Norfolk Vanguard Offshore Wind Farm

Statement of Common Ground

Natural England

Applicant: Norfolk Vanguard Limited
Document Reference: Rep1 - SOCG - 13.1
Revision: 1

Figure 2.1 *Sabellaria spinulosa* reef mapping by the Applicant and Natural England

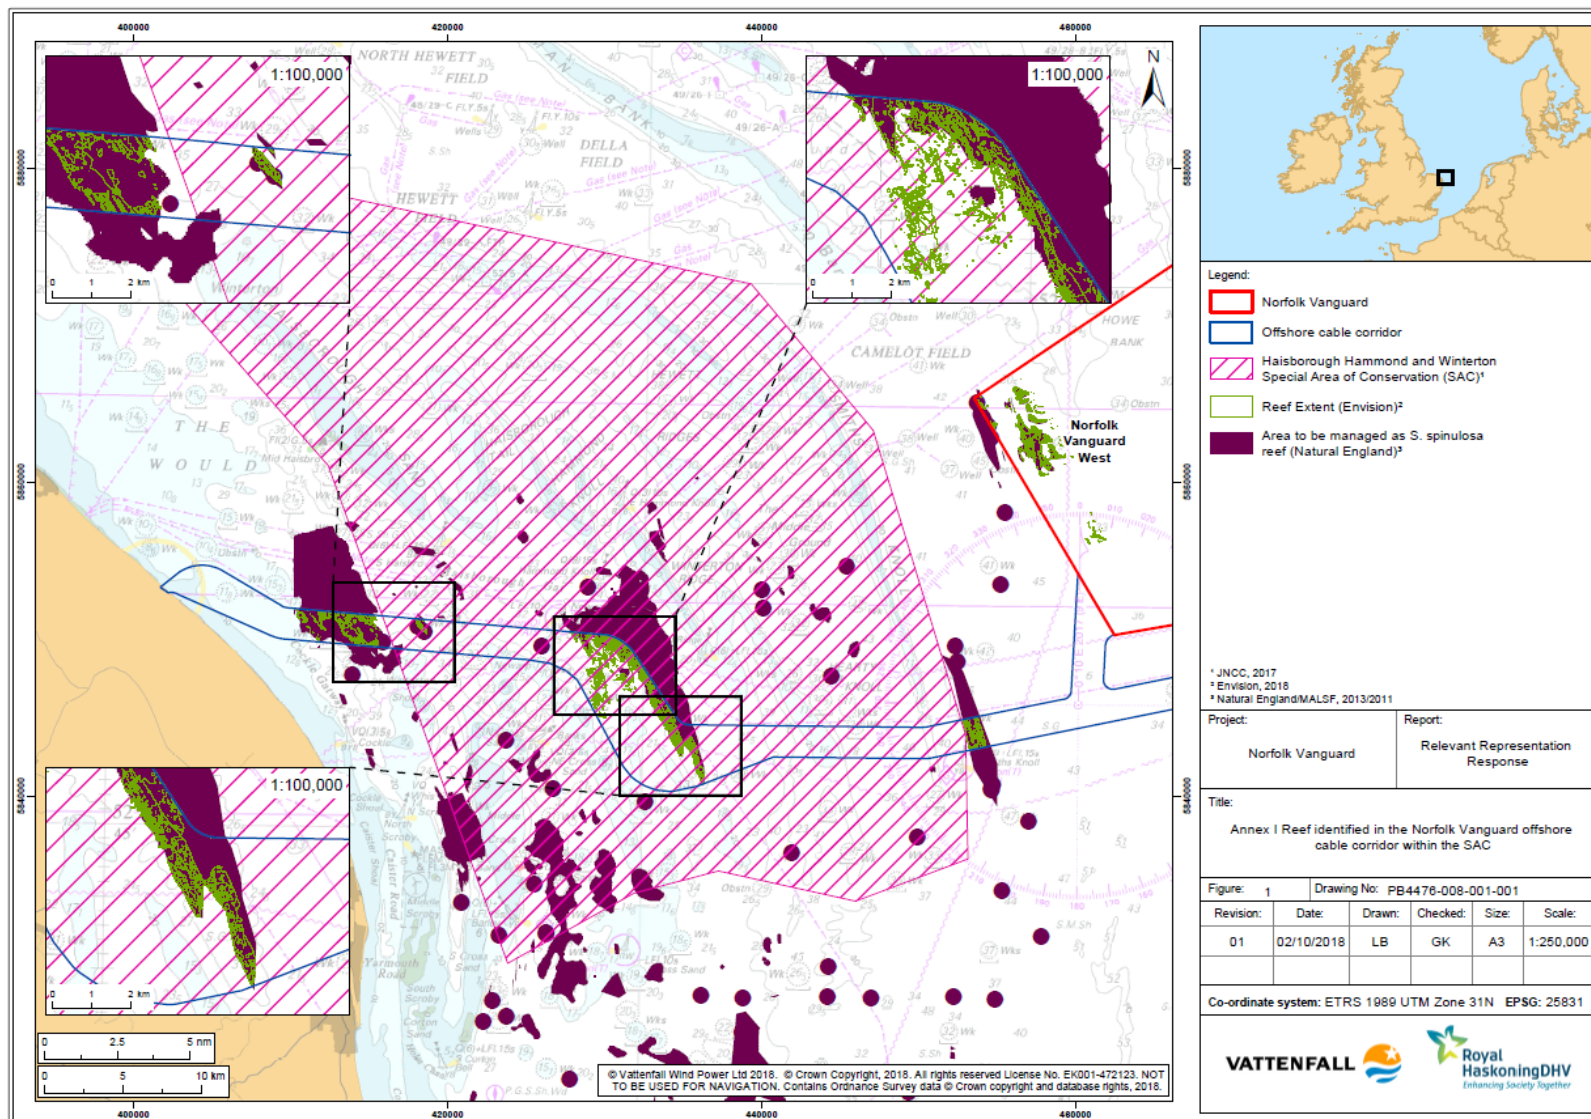
The approach to <i>S. spinulosa</i> reef mapping is appropriate to inform the EIA based on the data available.	Not agreed. Natural England has uncertainty associated with <i>S. spinulosa</i> reef mapping due to the ephemeral

<p><i>S. spinulosa</i> is an ephemeral, rapidly growing opportunistic species; pre-construction surveys targeted at establishing the presence, location and extent of <i>S. spinulosa</i> reef habitats are therefore required to enable effective micro-siting where possible.</p> <p>The assessment provides consideration of the impacts if micro-siting is possible and if it is not possible (see Assessment Findings sections below).</p> <p>A cable specification, installation and monitoring plan, must be agreed with the MMO in consultation with Natural England as discussed under ‘Mitigation and Management’ below. This will provide the mechanism to agree cable routing/micro-siting.</p>	<p>Not agreed, parameters/clear commitments are required in the DCO rather than the simple statement “where possible”.</p> <p>Natural England would want to see that all Annex I <i>S. spinulosa</i> will be avoided.</p> <p>The impact on <i>Sabellaria spinulosa</i> reef needs to be fully assessed if micro-siting is not possible and cable installation is still permitted.</p>

Figure 1 Predicted beach levels in 2025, 2055 and 2105 with indicative cable depth and angle shown.

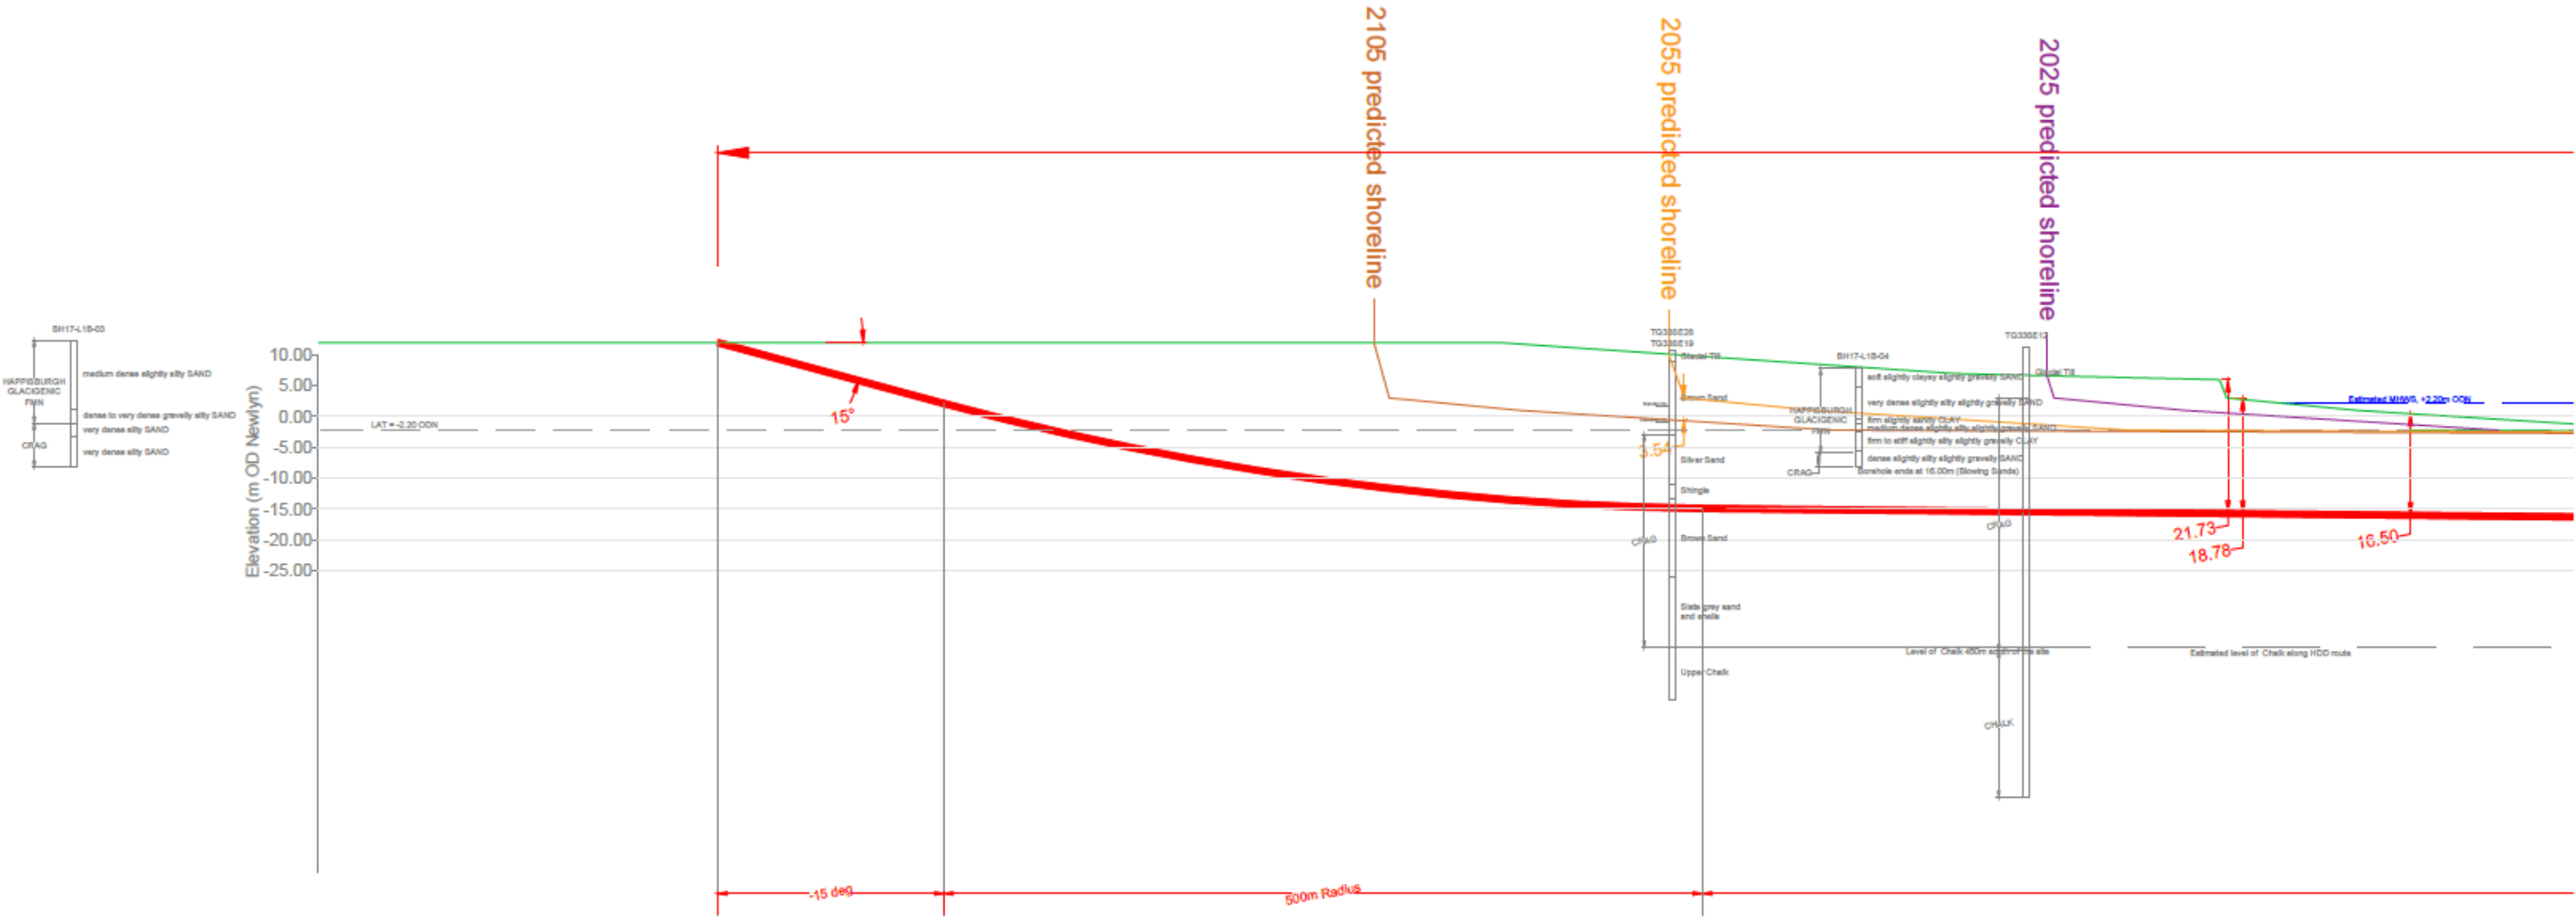
As well as the eroding cliffs, beach erosion is expressed as the vertical downward movement of the average beach surface level. Expected beach level is important for determining depth, trajectory and exit point of the Norfolk Vanguard export cables at landfall (Figure 1). Beach level at Happisburgh South has

Figure 1 graphically illustrates the existing and predicted shoreline position and beach levels at Happisburgh South in 2025, 2055 and 2105 based on the NNDC SMP (the most conservative forecast as shown in Table 2) alongside an indicative landfall drill profile. Figure 1 clearly shows the cables will remain buried beyond the predicted erosion levels up to 2105. Due to the proposed burial depth, Norfolk Vanguard Ltd is confident that the cables will remain buried despite potential vertical erosion fluctuations, with burial depths also including a conservative risk mitigation of unexpected accelerated erosion rates. This therefore represents a highly precautionary cable burial as the life of Norfolk Vanguard is expected to be around 35 years.

- The HDD will be secured beneath the surface of the shore platform and the base of the cliff. The cable will additionally be located at sufficient depth to account for downcutting as cliff erosion progresses (Figure 1), and so will not become exposed during the design life of the project.
